VIA EMAIL & USPS
June 14, 2024

Re: Response to May 22, 2024 Technical Deficiency Letter
Minard Mine – SMP 08230301
Bishop Brothers Construction Company, Inc.
Wysox Township, Bradford County, Pennsylvania

Title: Ditch 1 - REMOVED FROM DESIGN 06/11/24	Site:	Company:	Permit Number:
Prepared by:	Telephone Number:	Date:	Sheet 1__ of 1__

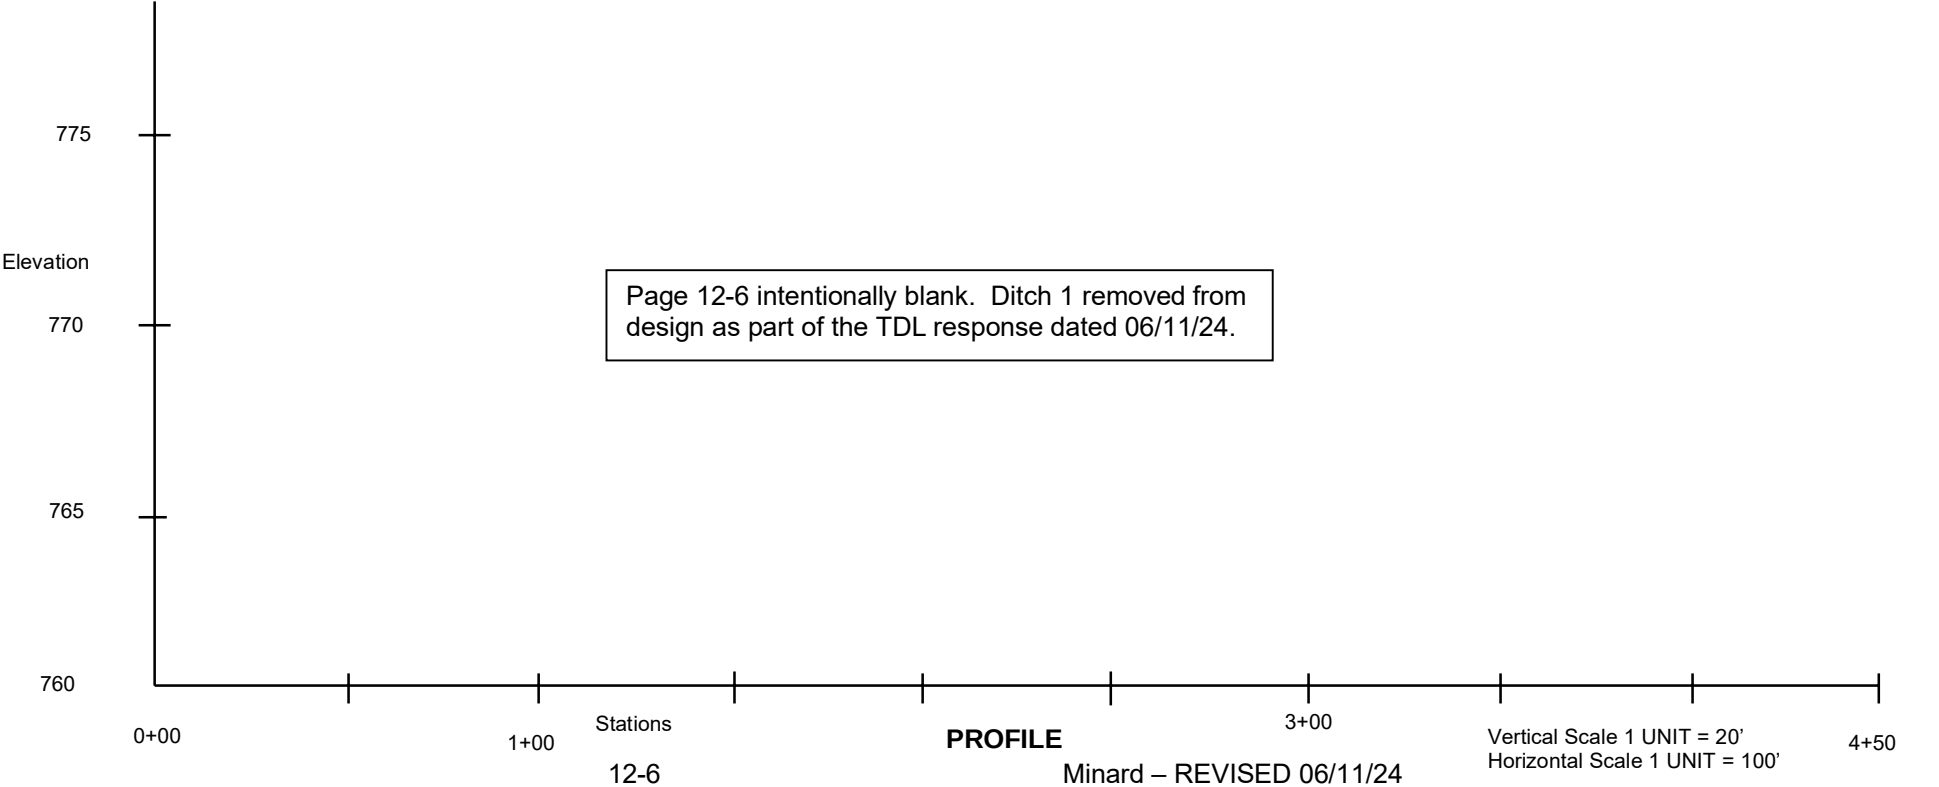
3. The response to Module 13, Comment 5 did not fully address the comment. Page 13-5 indicates that Basin 2 was designed to provide a total of 12 hours of detention time based upon the dewatering rate of the pit pump. This page goes on to indicate that a 200 gallon per minute pump is proposed. Page 10-2 indicates that conveyance of pit water from the sump to Basin 2 can be achieved by Ditch 1 (gravity drainage) or by pumping. Page 12-6 indicates that Ditch 1 has a peak discharge of 190 cubic feet per second which converts to 85,278 gallons per minute. Please clarify how Basin 2 will have sufficient capacity to provide a 12-hour detention time should the pit sump fill up to a point where Ditch 1 begins conveying flow to Basin 2 at its peak discharge rate. The elimination of the gravity drainage option for dewatering the pit sump may be the simplest way to address this item. {25 Pa Code 77.458, 77.525, 77.526, and 77.531}

5. The Basin 2 potential inflow is listed as 180 cubic feet per second on page 13-5, but the calculations provided on page 13-19 and the design for Ditch 1 on page 12-6 list a peak discharge rate of 190 cubic feet per second. Revise these areas to be consistent. {25 PA Code 77.458, 77.525, 77.526, and 77.531}

Ditch 1 has been removed from the design. Exhibit 9, Exhibit 9.1, Module 10.1 (pg 10-2) and Module 12 (pg 12-6) revised.

Page 12-6 intentionally blank. Ditch 1 removed from design as part of the TDL response dated 06/11/24.
